Addendum/Addenda

No./N° 2

Project Description / Description de projet M19 Stores Amalgamatim Phase 1		
Solicitation No./ N° de sollicitation 17-22098	Project No./N° de projet 5463	W.O. No./N° d'ordre de travail A1-009909/99
Departmental Representative / Représentant Ministériel Janik Leroux	Date November 29, 2017	
Notice: This addendum shall form part of the tender documents and all conditions shall apply and be read in conjunction with the original plans and specifications.		Nota: Cet addenda fait partie intégrale des dossiers d'appel d'offres; toutes les conditions énoncées doivent être lues et appliquées en conjonction avec les plans et les devis originaux.

dwg.no. **5463-M01** dessin no.

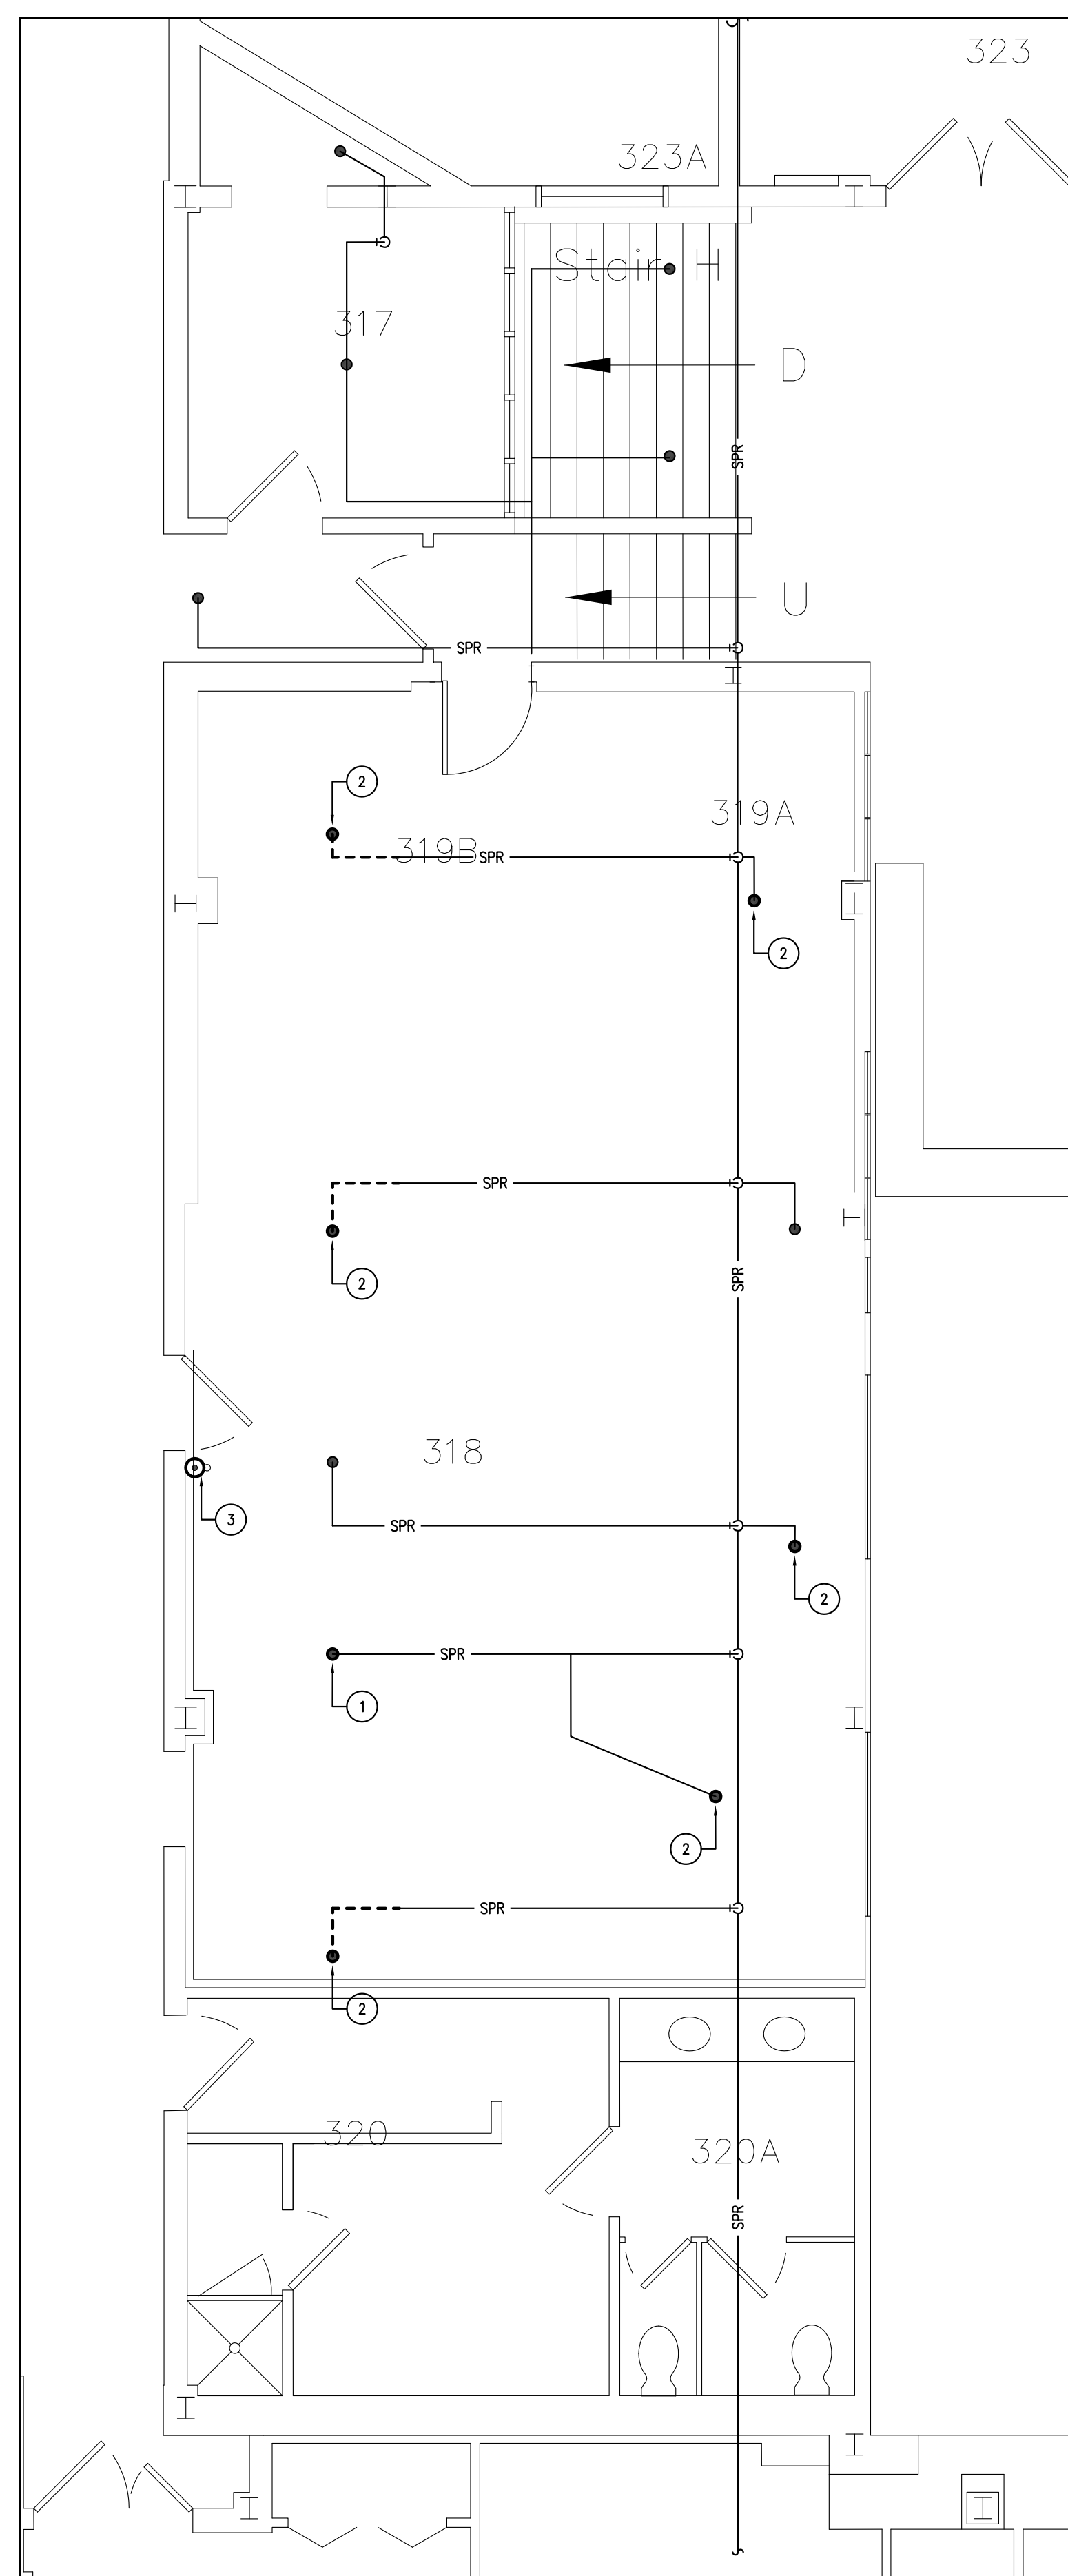
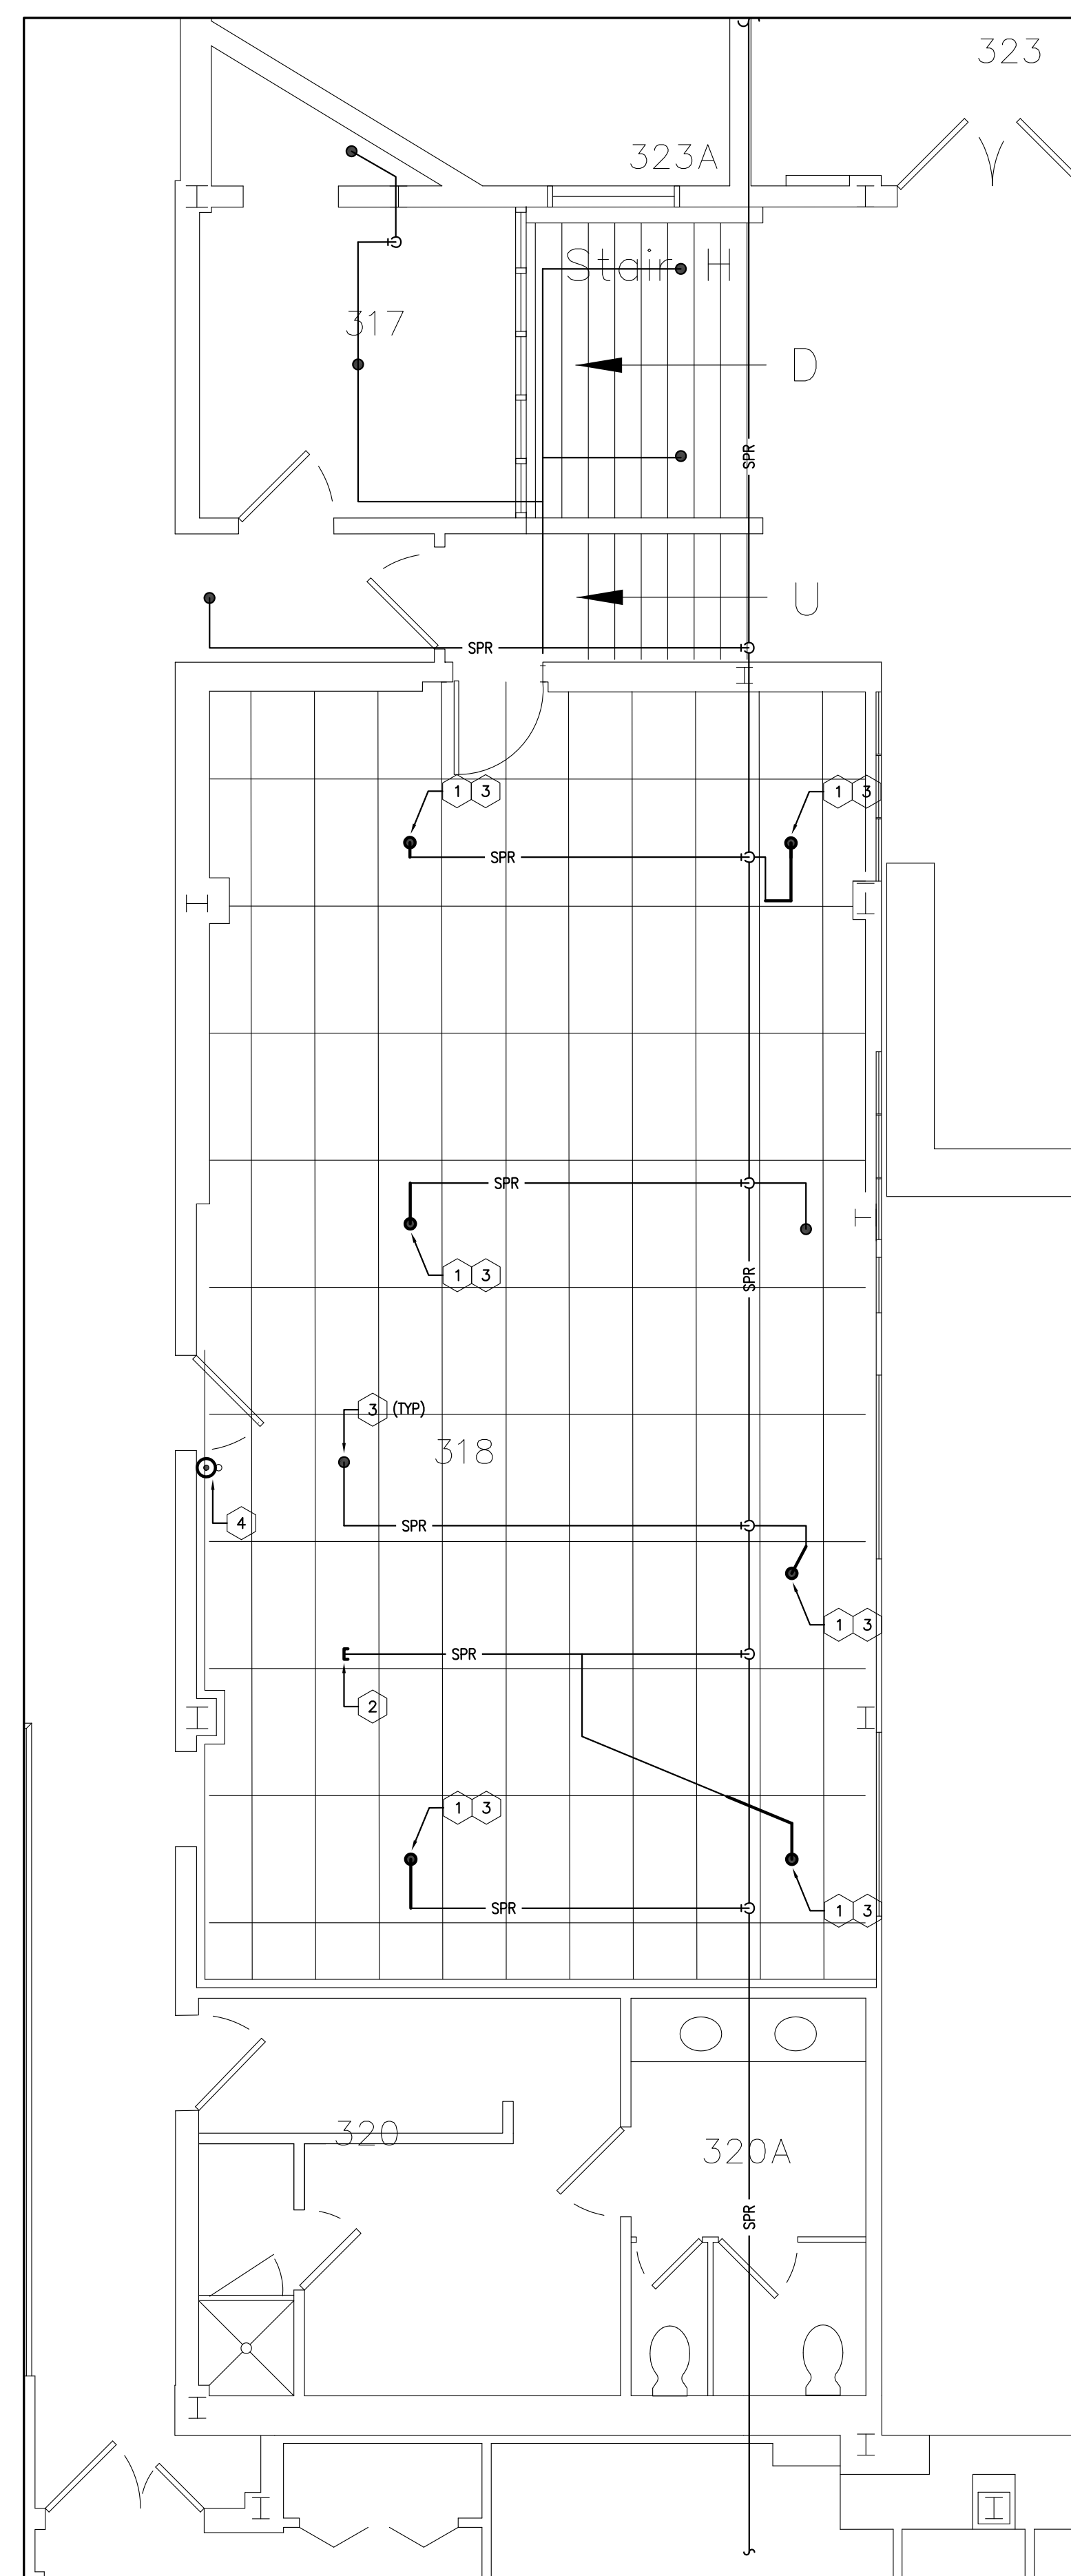
- a. Replace original tender drawings with attached Addendum #2 drawings:
 - i. 5463-M01,
 - ii. 5463-M02
 - iii. 5463-M03
